Permanente Creek Flood Protection Project

Sixth Addendum to the Final Subsequent Environmental Impact Report

December 2020

Figure 1. Enhancement Area Overview

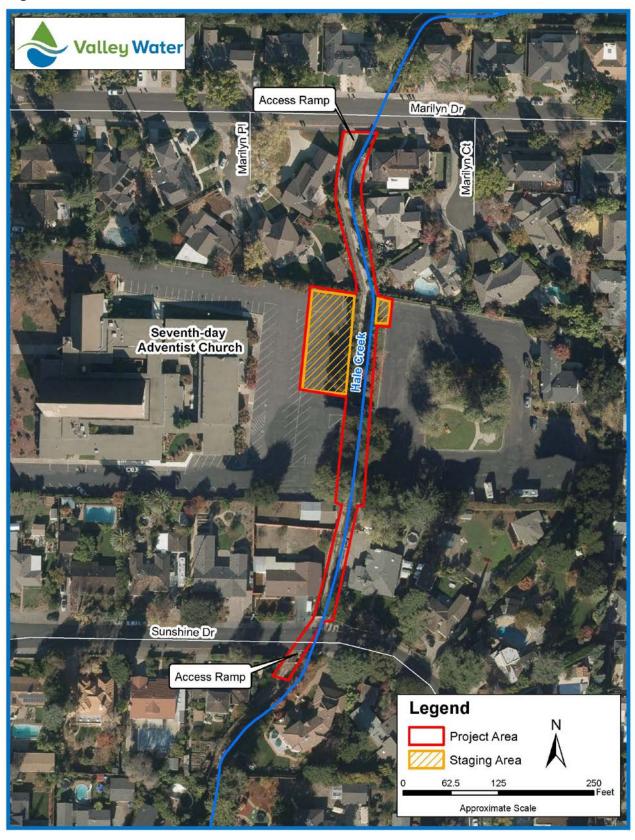
The 2012 EIR described channel improvements on Hale Creek that would involve replacing the existing concrete channel, from the confluence of Permanente Creek upstream to Rosita Avenue, with a vertical-walled concrete channel that would be wider and deeper. While Valley Water intends to maintain the channel enlargement element, the Project would be modified to enhance the channel with natural substrates and vegetation (rather than a concrete bottom) in an approximately 650-foot long reach (herein referred to as the "enhancement area") located

between North Sunshine Drive and Marilyn Drive in Mountain View and Los Altos (**Figure 1**). The purpose of this change is to restore geomorphic and habitat functions to the reach while providing improved flood protection. The details of the work in this area are included below.
